Work Order ID 106448

Item Name: Crosstube Mid Aft

DRAWING NO. D206-667-247	TITLE CROSSTUBE ASS'Y (206L MID AFT)	REV. A	DART AEROSPACE LTD ENGINEERING ORDER		D.E.O. NO. D206-667-247-A-1	SHEET NO. SHEET 1 OF 1	SCALE NTS
DRAWN <i>qp</i>	CHECKED <i>ASS</i>	MFG. APPR. <i>KS</i>	APPROVED <i>JMD</i>		DE APPR. <i>#</i>		
DATE 11.07.15	DATE 11.07.20	DATE 11.07.21	DATE 11/07/21		DATE 11.07.21

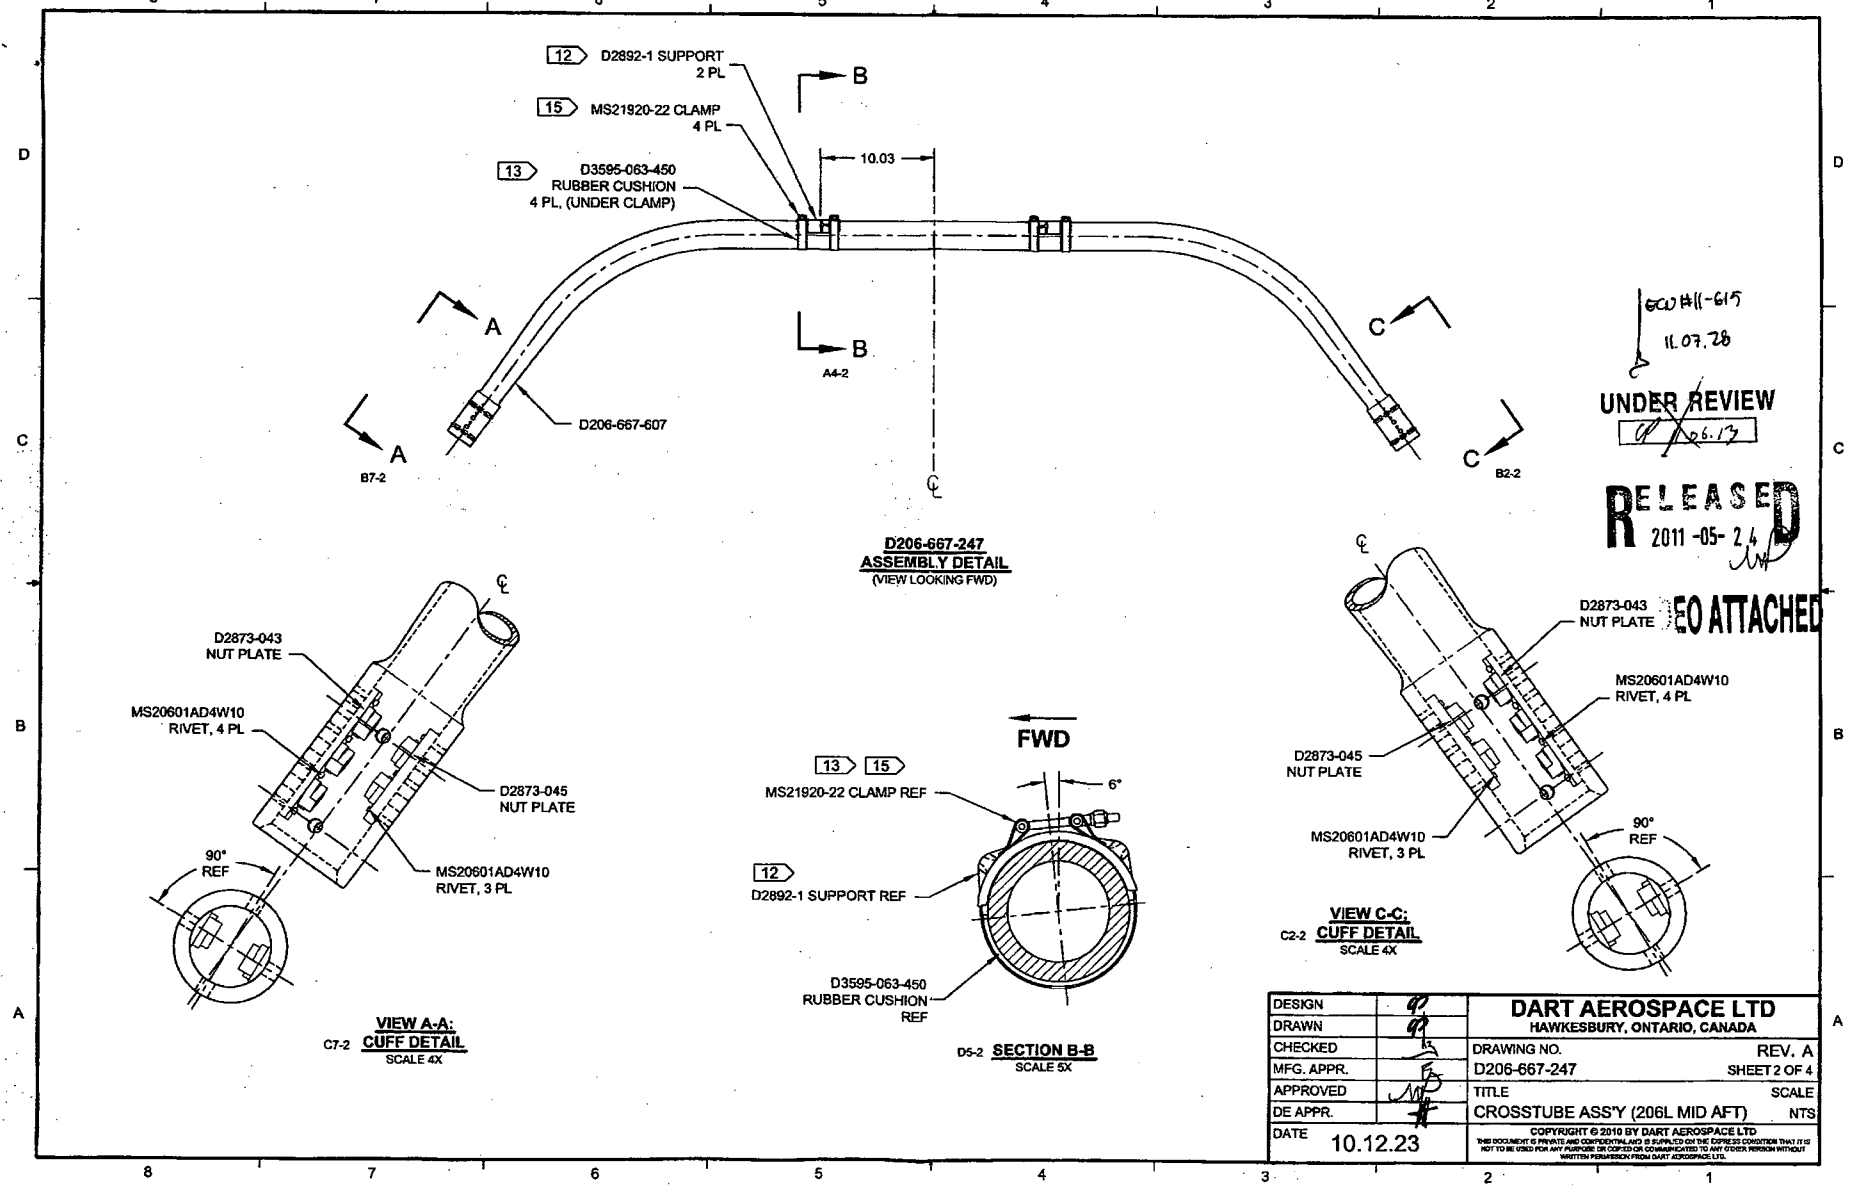
REPLACE MAGNOBOND WITH PROSEAL.

NOTE 12 & 15, SHEET 1 IS AMENDED AS FOLLOWS:

- 12) TO INSTALL D2892-1 SUPPORT: ABRASE MATING SURFACE OF SUPPORT AND CROSSTUBE WITH 180-GRIT SANDPAPER AND REMOVE RESIDUE WITH MEK (OR EQUIVALENT). APPLY A 0.04" TO 0.07" THICK LAYER OF PROSEAL 890 CLASS B-2 (OR AMS-S-8802 CLASS B-2) SEALANT TO MATING SURFACE OF SUPPORT.
- 15) TORQUE CLAMPS 80 TO 100 IN-LB. ENSURE AT LEAST 1.5 THREADS SHOWING IN SAFETY AND THAT NUT HAS NOT BOTTOMED-OUT AFTER TORQUING. **PRIOR TO PACKAGING, RE-CHECK TORQUE ON CLAMPS AFTER PROSEAL 890 SEALANT HAS CURED FOR 72 HOURS.**
